Report of the Committee on**Lightning Protection****John M. Tobias, Chair**

This portion of the Technical Committee Report of the Committee on **Lightning Protection** is presented for adoption.

This Report on Comments was prepared by the **Technical Committee on Lightning Protection**, and documents its action on the comments received on its Report on Proposals on NFPA 780, **Standard on Lightning Protection**, 2004 edition, as published in the Report on Proposals for the 2007 June Meeting.

Figure 4.8.2(a)

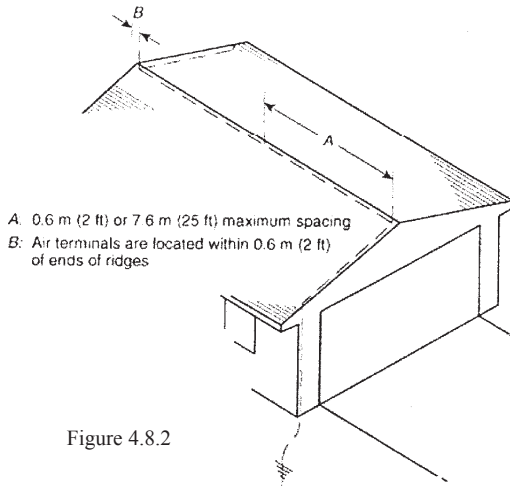
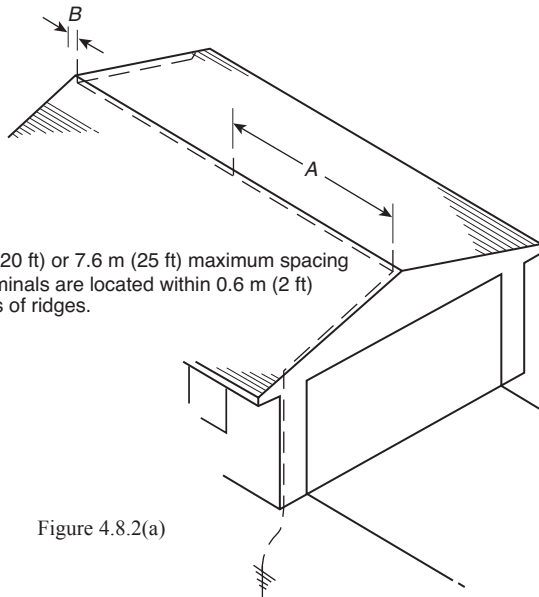
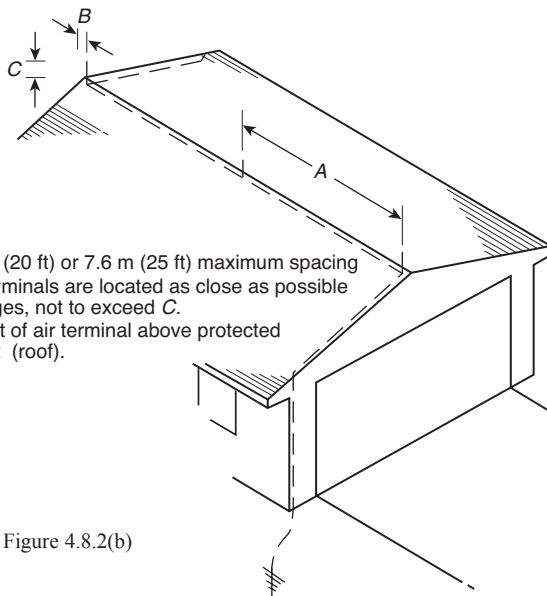
Comment on Proposal No: 780-35

Substantiation: Rejection of the original proposal 780-35 leaves an established gap in lightning protection for taller structures. Yet, the proposal as originally written was too restrictive for Class I structures. (See voting explanations in ROP A2007.) This comment addresses the need to place air terminals closer to a roof edge for class II structures in order to minimize the possibility of bypass and attachment to a roof edge. In addition, this comment brings NFPA 780 air terminal placement requirements into closer coordination with IEC lightning protection standards.

Further consideration given to this issue in the 780 2007 ROP noted that the distance of air terminals to roof edge was dependent upon height of the structure, as Mr. Caie notes, referring to well established IEC standards. This comment addresses that point in the context of NFPA 780 techniques and terminology and brings 780 into closer coordination with IEC lightning protection standards.

Change 4.8.2 to read as follows:

4.8.2* Location of Devices. As shown in Figure 4.8.2, the distance between strike termination devices and ridge ends on pitched roofs or edges and outside corners of flat or gently sloping roofs shall not exceed 0.6 m (2 ft).

Committee Statement: The committee changed the text of 4.8.2 to emphasize that strike termination devices should be installed close to roof edges. Annex material was added to encourage minimizing air terminal to edge distance.

Figure 1 Types of wind turbine blades.

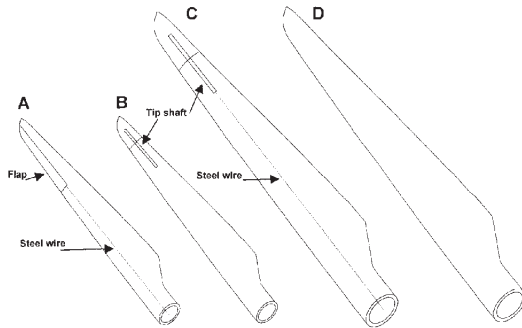
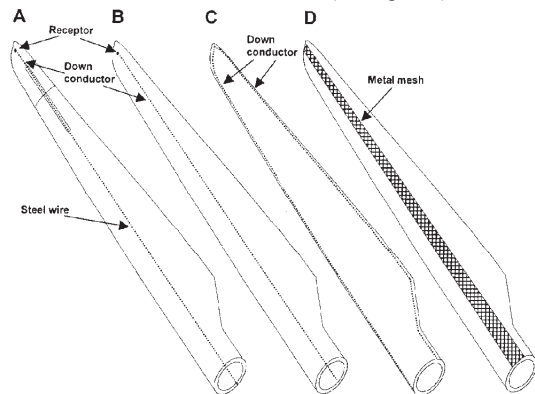
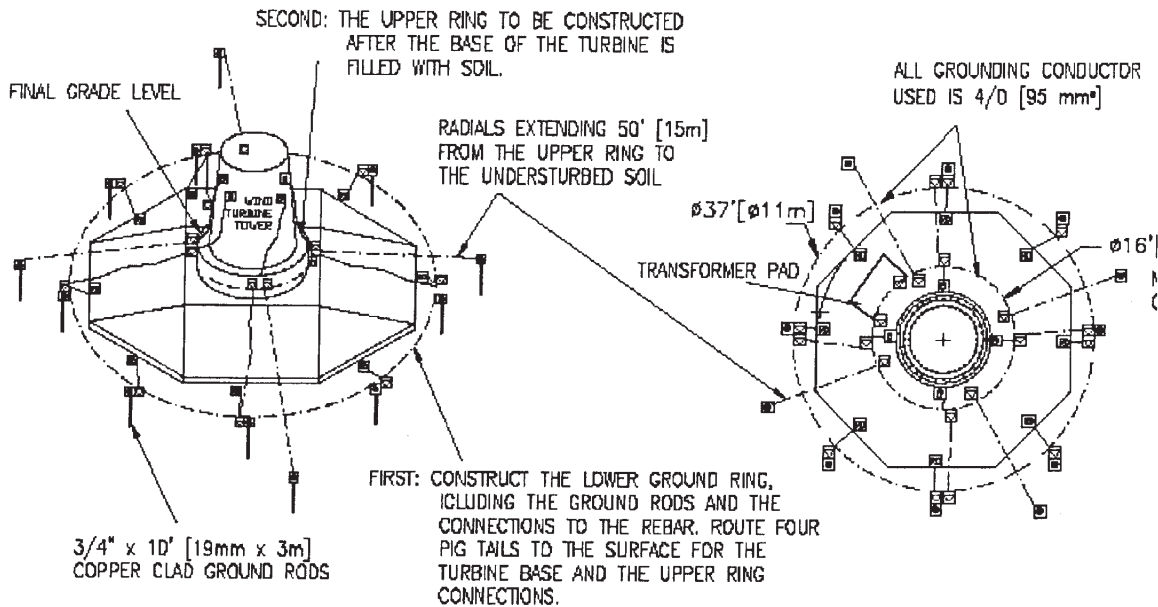
Comment on Proposal No: 780-41

Recommendation: Add new text to read as follows:

Substantiation: The proposal as written inadequately addresses this class of structure. The class of structures designated as wind turbines, falling generally under structures with rounded roofs due to the similarity of the arc of the rotating blades, need special zone of protection consideration due to the nature of the moveable assemblies and need to be addressed in this section. In order to adequately address the zone of protection issues (and the consequent issues of strike termination) additional (non-normative) annex material is required for explanatory purposes.

Figure 4.8.8.3a [Existing Figure 4.8.8.3, 2004 ed., (no change)]

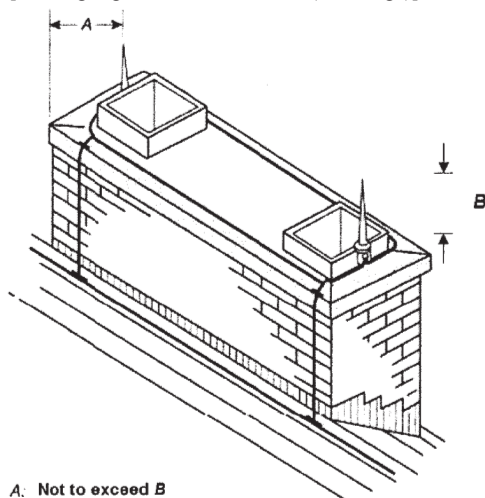
780-20 Log #31 Final Action: Accept in Principle (4.8.8.3)**Submitter:** John M. Tobias, US Army CELCMC**Comment on Proposal No:** 780-42**Recommendation:** See the following figures:

4.8.8.3 Required strike termination devices shall be installed on Class I chimneys and vents (under 75 feet in height above grade), as shown in Figure 4.8.8.3a, so that the distance from a strike termination device to an outside corner or the distance perpendicular to an outside edge shall be not greater than 0.6 m (2 ft).

Required strike termination devices shall be installed on Class II (greater than 75 ft. in height above grade) chimneys and vents, as shown in Figure 4.8.8.3b, so that the distance from a strike termination device to an outside corner or the distance perpendicular to an outside edge shall be not greater than the height of the device above the protected chimney or vent.

Annex material was added to encourage placement of air terminals at corners. The change satisfies the submitter’s intent.

Figure L.2(b)

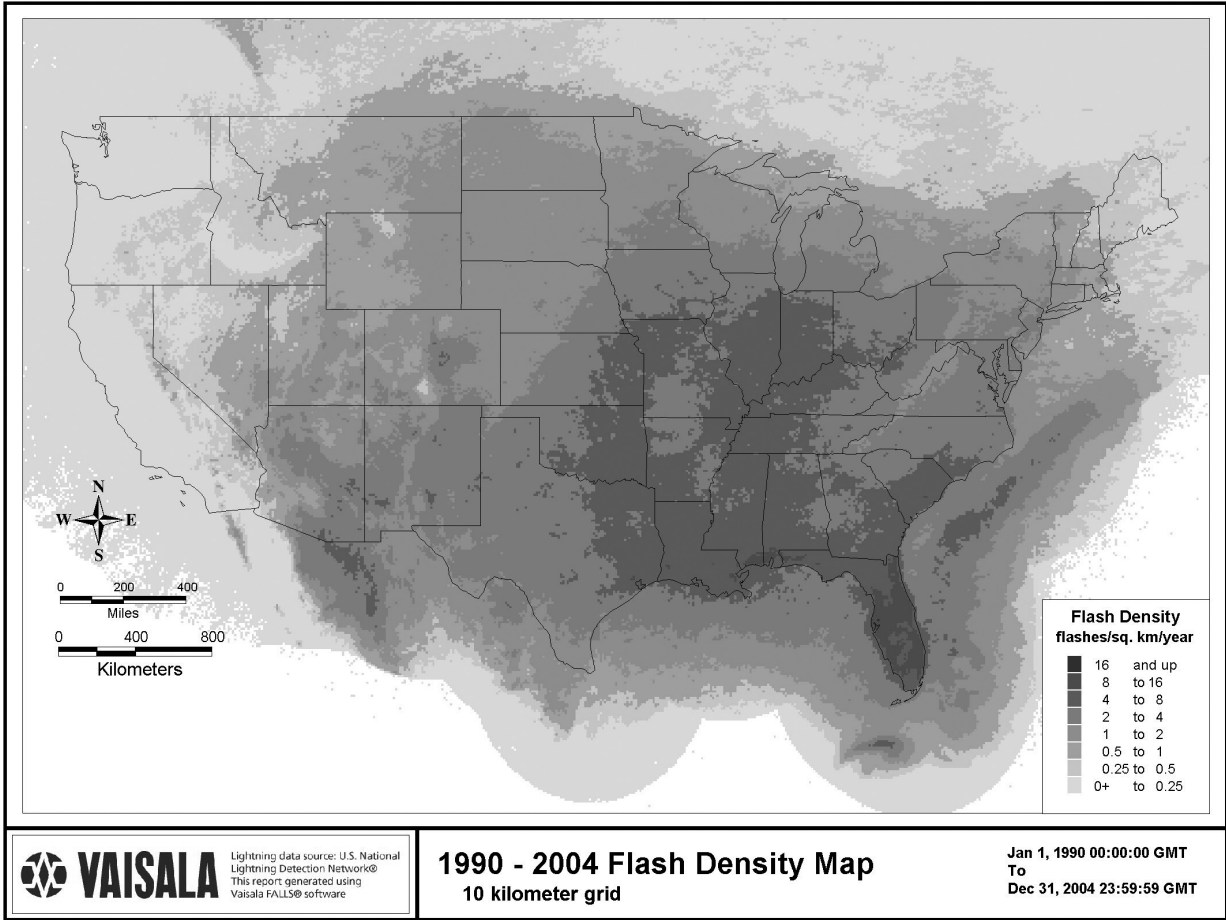
Insert new Figure L.2(b)

New Figure L.2(b) to read as follows:

FIGURE L.2(b) 1990-2004 Average U.S. Lightning Flash Density Flashes per Square Kilometer per Year. (Courtesy Vaisala Inc.)
